Accessibility Assessment Report

Bungendore High School
Birchfield Drive, Bungendore NSW 2621

Client: NSW Department of Education

Report Number: 230468.01

Block A – Ground Plan

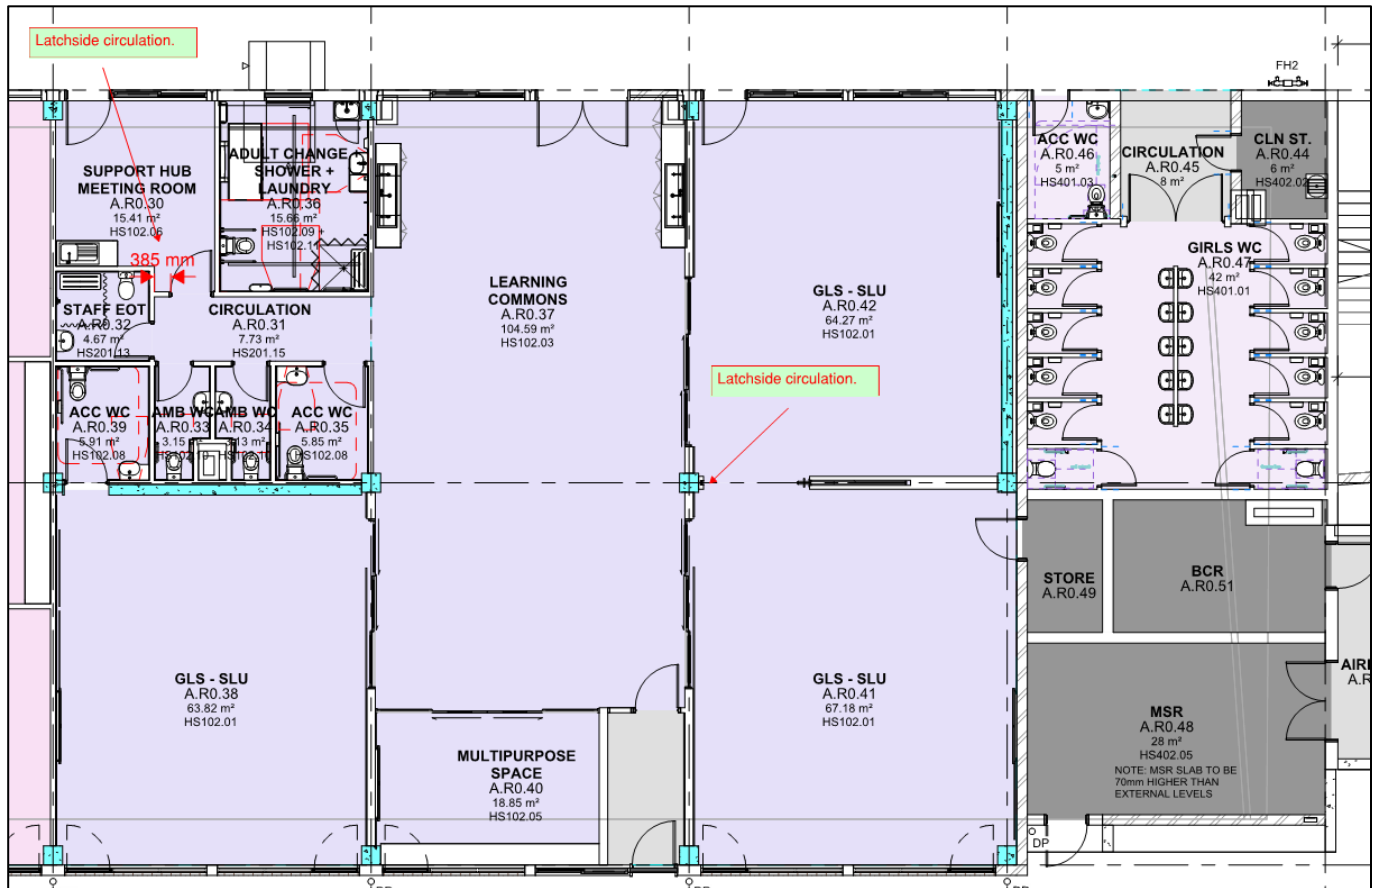
Compliance Status	
Design Detail	<p>Access required to all areas normally used by the occupants.</p> <p>Refer to the attached mark-up for various comments relating to this clause.</p> <p>Performance justification required to address the disconnect between the accessible entry (SELU entry) and the entry stair at street level. (BCA D4D3(1)(a)). An accessible sign is to be provided at the stair entry at street level identifying location of SELU access as the accessible entry part.</p> <p>Compliance generally indicated and readily achievable subject to design detailing.</p>

Compliance Status	
Design Detail	<p>Accessways to be provided from pedestrian entrance at the property boundary, to and between all buildings and between accessible carparking and buildings.</p> <p>Refer to the attached mark-up for various comments relating to this clause.</p> <p>Compliance generally indicated and readily achievable subject to design detailing.</p>

Compliance Status	
Design Detail	<p><u>Small building concession</u></p> <p>Not applicable.</p> <p><u>Turning spaces</u></p> <p>A suitable 1540mm x 2070mm turning space will satisfy this provision. Refer to the attached mark-up for commentary relating to turning spaces.</p> <p><u>Passing spaces</u></p> <p>Compliance required to corridors over 20m in length.</p> <p><u>Stairs and ramps</u></p> <p>Refer to the attached mark-up for various matters relating to stairways, walkways & ramps.</p> <p>Detailing to Clause 10, 11 and 12 of AS1428.1-2009 required for assessment.</p>
